Keystone RV Company

SERVICE ADVISORY # 19-356

Cougar 32RDB Ceiling Vents

Models Included: 2018 - 2020 Cougar 32RDB

Fig. 1

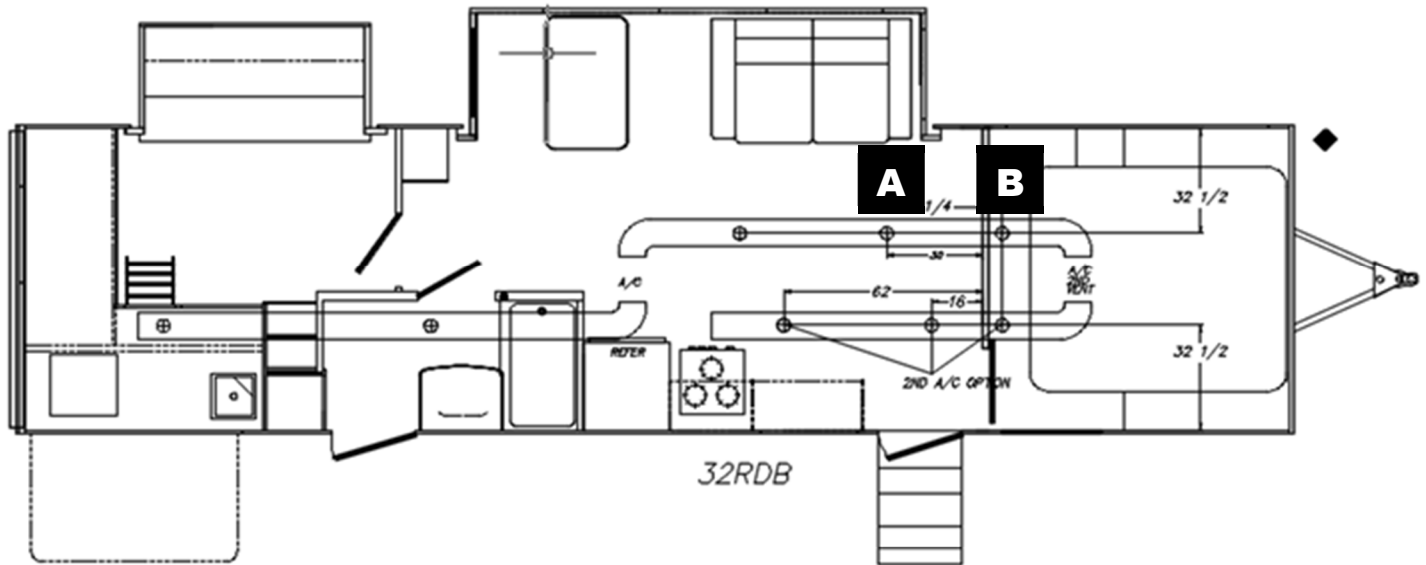
It has been determined that the Cougar 32RDB units may not have the adequate amount of A/C ceiling vents installed. The following procedure describes the locations and how to install the required A/C ceiling vents.

Inspect the existing ceiling vents and compare to Figure 1. There should be a minimum of 5 A/C vents: one in the bunk room, one in the bathroom, two in the main living area, and one in the bedroom. The forward living room vent (A) and bedroom vent (B) may or may not be installed, inspection is necessary. The second A/C option is also included on Figure 1 and indicates where the holes can be drilled. The 2nd A/C option is not standard on every unit, to verify this option use the “**Search Unit Info**” function on Key Express.

Locate (measure) for the missing A/C ceiling vents, Figure 1. The vents in the above figure may or may not be installed, inspection is necessary.

Using measurements from Figure 1 and a 5" hole saw, add vents as needed, drilling into ceiling panel and A/C duct, being careful that you do not drill into the top side of the A/C duct.

Install KRV#101886 Grill – 5" – Ducted Ceiling – AC in the locations indicated on Figure 1 using HVAC tape to seal the vents to the ducting.

The A/C vent holes A and B should be located 32 ½" from the off-door-side inside panel, of the sidewall, to the center of the vent hole. The kitchen/living area A/C vent hole (A) is 30" from the bedroom divider wall. The bedroom A/C vent hole (B) is 5 ¾" from the bedroom divider wall. Drill hole through the ceiling panel and first side of the A/C ductwork in the ceiling.

If the unit has a second A/C, vent holes are located 32 ½" from door-side inside panel, of the sidewall, to the center of vent hole. Bedroom A/C vent hole is 5 ¾" from the bedroom divider wall, kitchen/living area A/C vent holes are 16" and 62" from the bedroom divider wall. Drill hole through the ceiling panel and first side of the A/C ductwork in the ceiling.
